SERVICE BULLETIN

SB97.8

Steering Diode Position
Machines/Models: SL-20

PURPOSE: To ensure proper elevated steering.

Figure 1

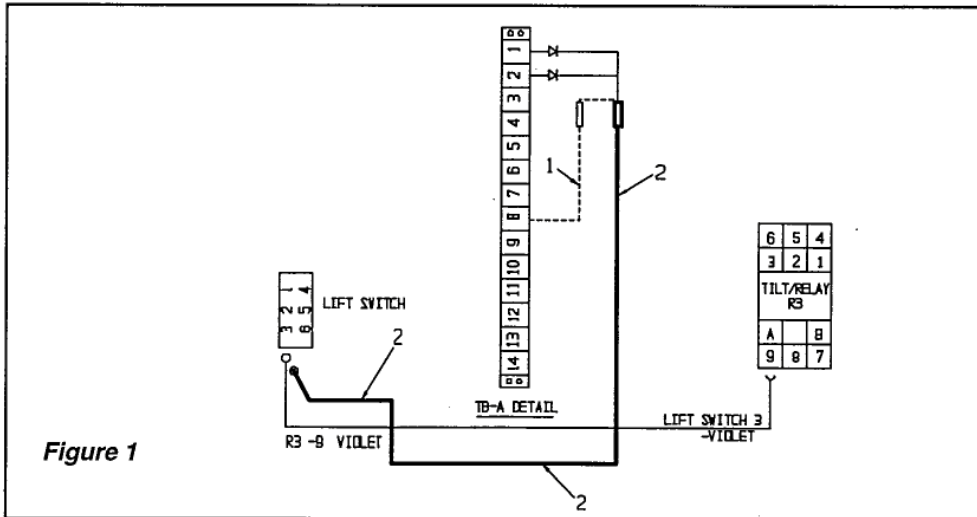
1. Disconnect battery negative.
2. Remove chassis control access panel cover.
3. Disconnect diodes at terminal 8 in the lower control box. Remove wire connector at end of diodes, discard disconnected wire and connector. (see ref. 1)
4. Install new wire connector (029620-002) to the disconnected ends of diodes and 6 inch wire (029456-099) to open end of the wire connector.
4. Route wire to chassis lift switch. (see ref. 2)
5. Install fork terminal (029610-002) to wire, connect fork terminal to same terminal as violet wire on the chassis lift switch.
6. Reinstall chassis control access panel cover.
7. Reconnect battery negative.
8. Perform function test.
